TO: Mayor David Still, City of Lawrenceville
ATTN TO: Helen Balch, Deputy Director, Planning and Development, City of Lawrenceville
FROM: Mike Alexander, Director, ARC Center for Livable Communities
RE: Development of Regional Impact (DRI) Review

Name of Proposal: Northside Hospital Gwinnett Expansion DRI 3858

2022 NORTHSIDE HOSPITAL GWINNETT EXPANSION DRI
City of Lawrenceville
Natural Resources Comments
February 7, 2023

Development of Regional Impact Assessment of Consistency with the Regional Transportation Plan

SITE PLAN
100-SC

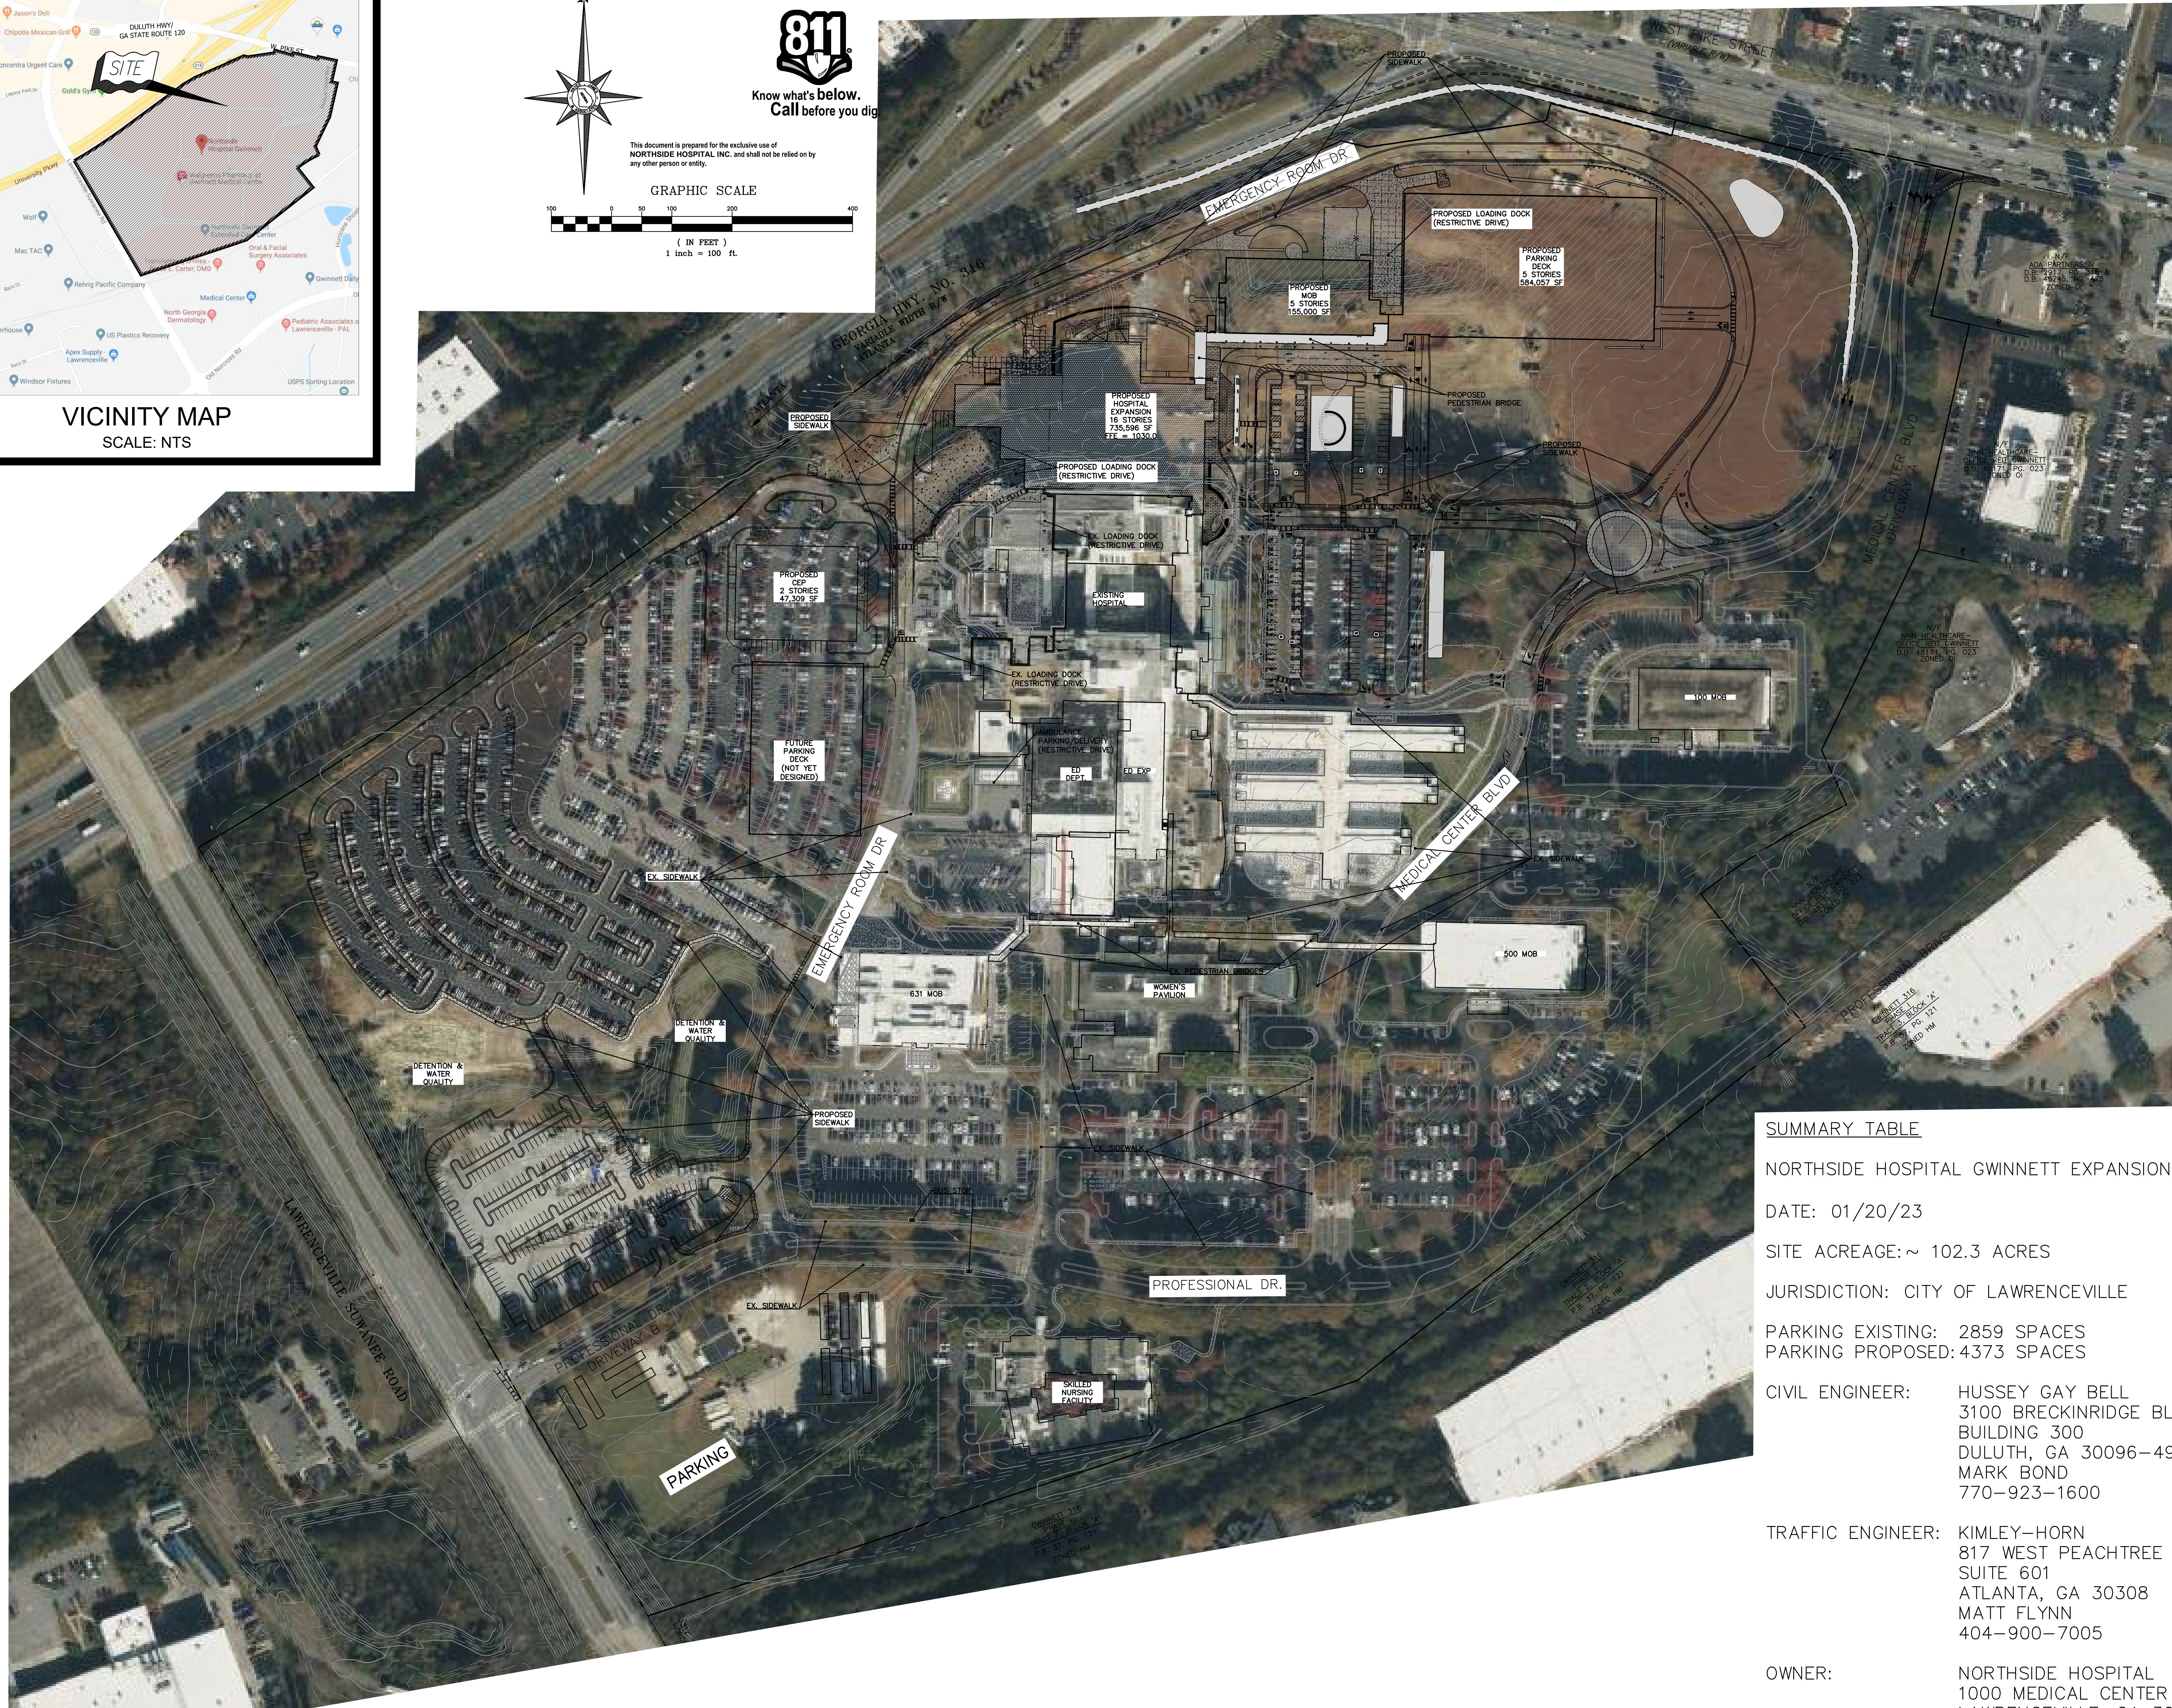
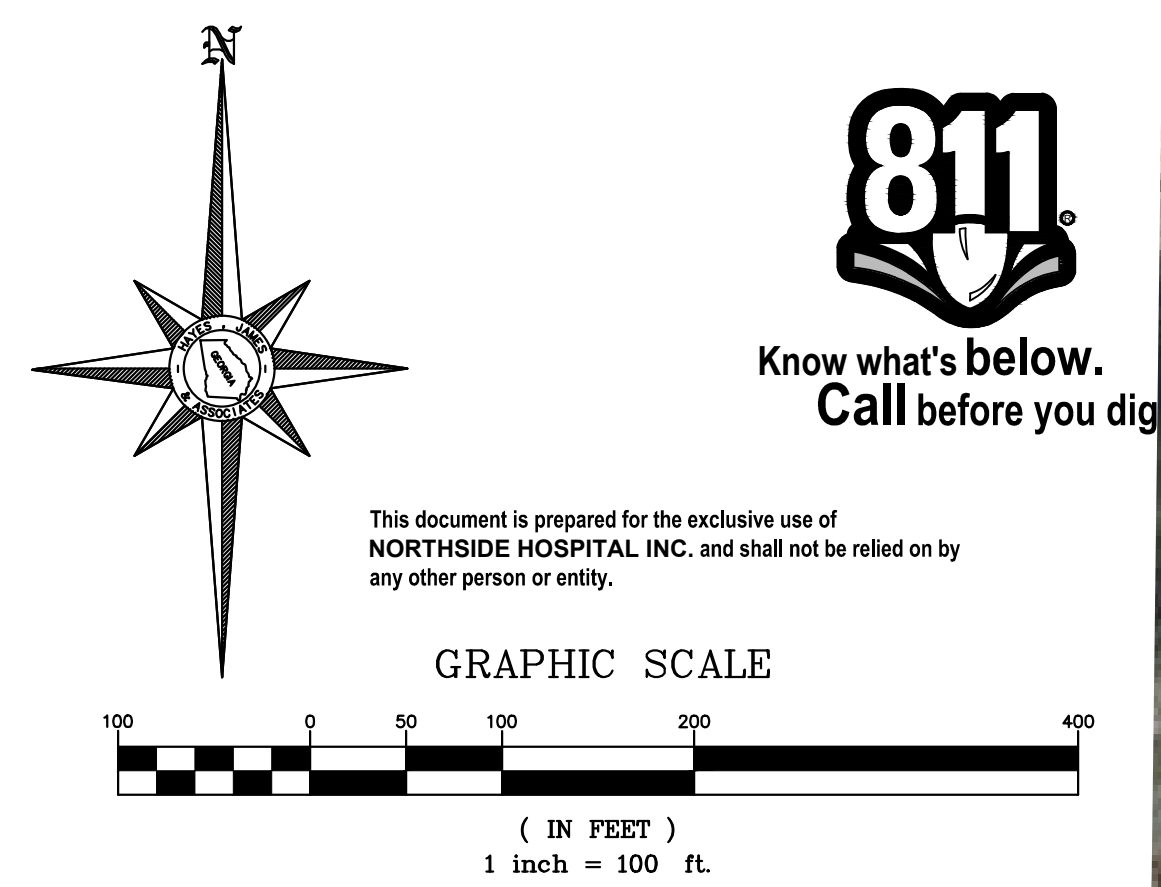
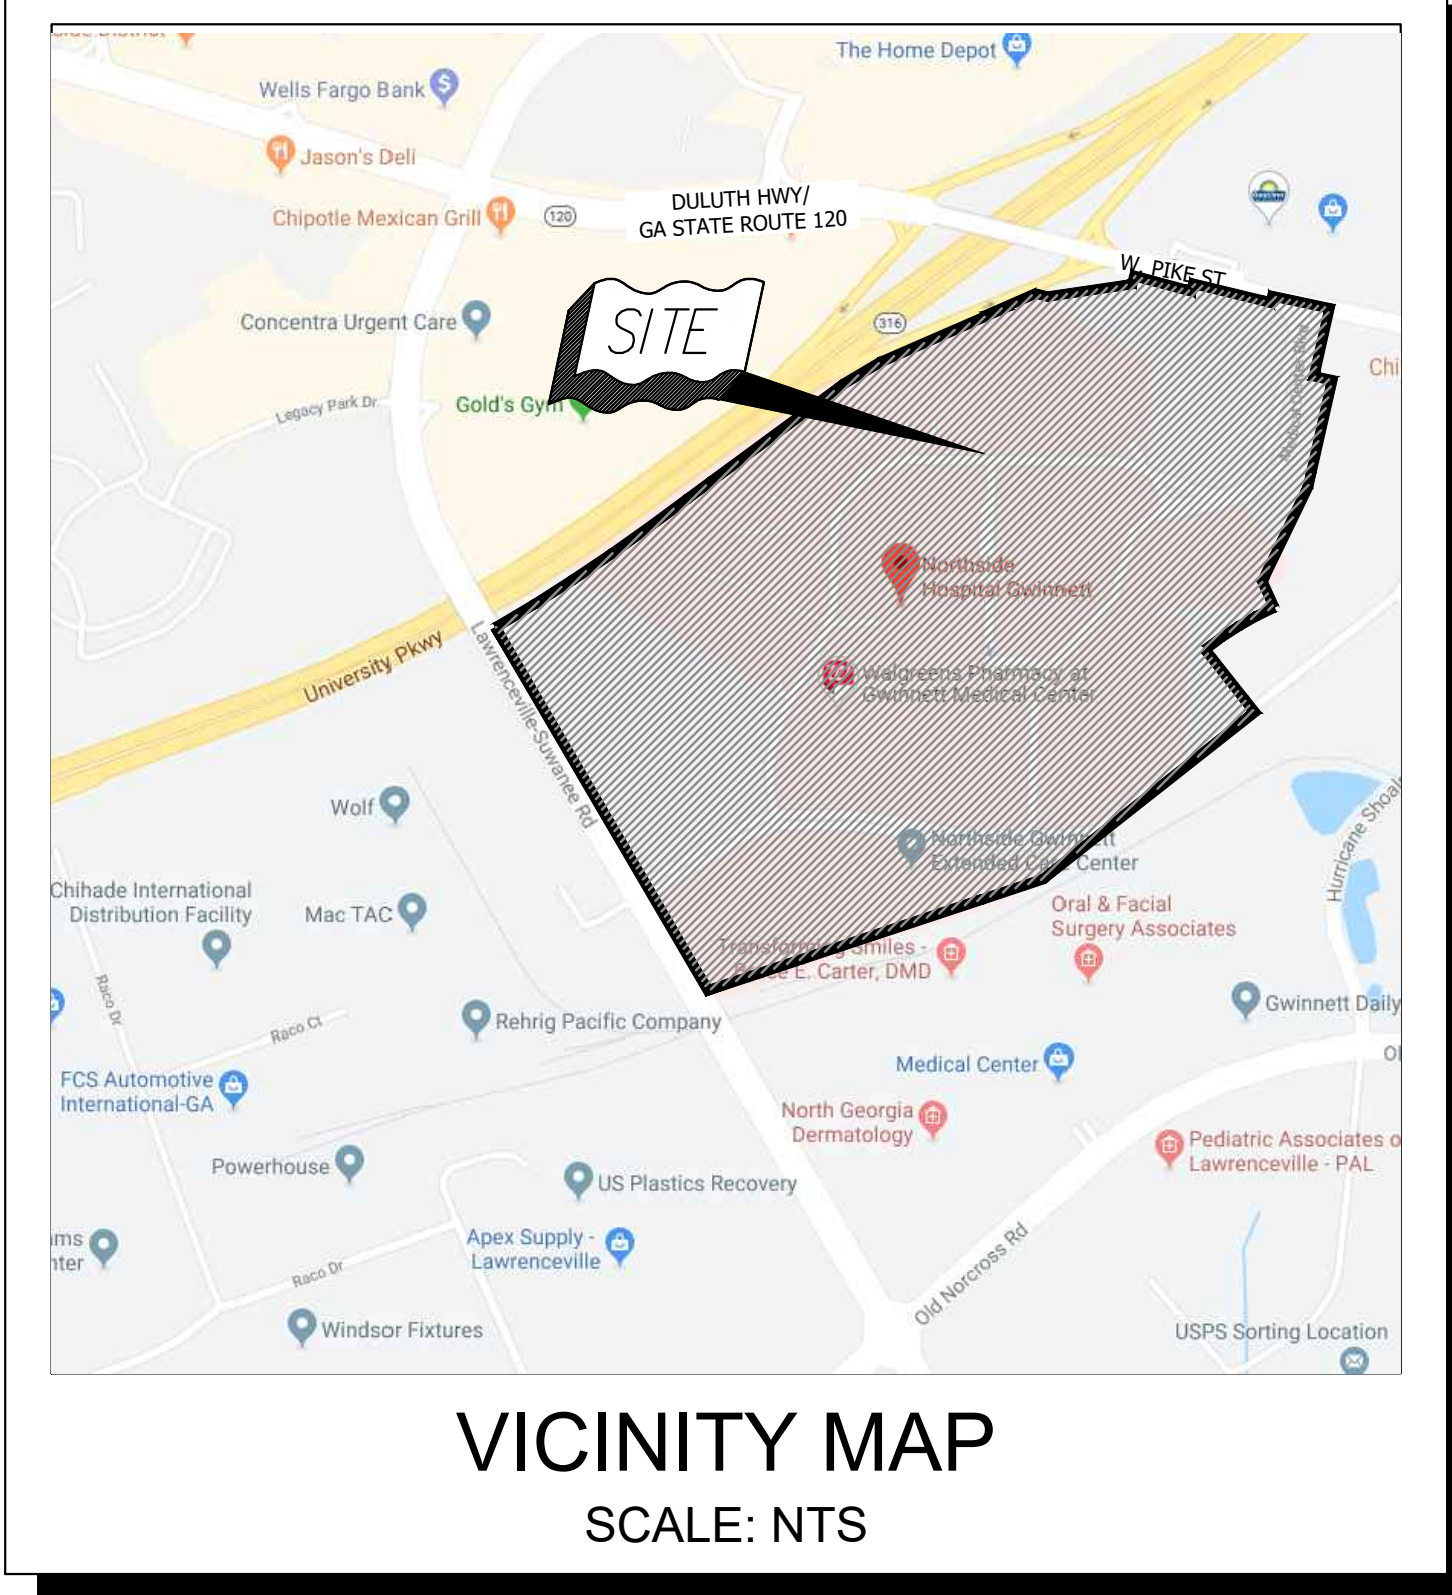
The TIS notes that "Pedestrian facilities are currently provided throughout the study network, though sidewalk gaps do exist." Additional attention should be given to substantially strengthening the pedestrian network within the 100-acre site to ensure easy, safe, and comfortable access to all internal destinations, the four Gwinnett County transit stops along Professional Drive, and potential pedestrian destinations along Duluth Highway. The Duluth Highway project frontage should include a comfortably wide sidewalk. To this end, a clearer plan view of the existing and proposed pedestrian network would be helpful.

A total of 1,560 spaces 2,545 spaces are proposed which is 985 more than the required amount. Ideally the number of spaces would be reduced with additional effort instead focused on increasing the usage of the four adjacent Gwinnett County Transit system stops on Professional Drive as well as the noted micro-transit system to be implemented by Gwinnett County. It would also be very helpful to note the location and format of the micro-transit route and stops so that pedestrian access to them can be ensured.

Both the USGS coverage for the project area and the project site plan show no blue line tributaries on this property. Any unmapped streams on the property may be subject to the City Stream Buffer Protection ordinance and 25-foot Sediment and Erosion Control buffer. Any unmapped waters of the state will also be subject to the State 25-foot Sediment and Erosion Control buffer.
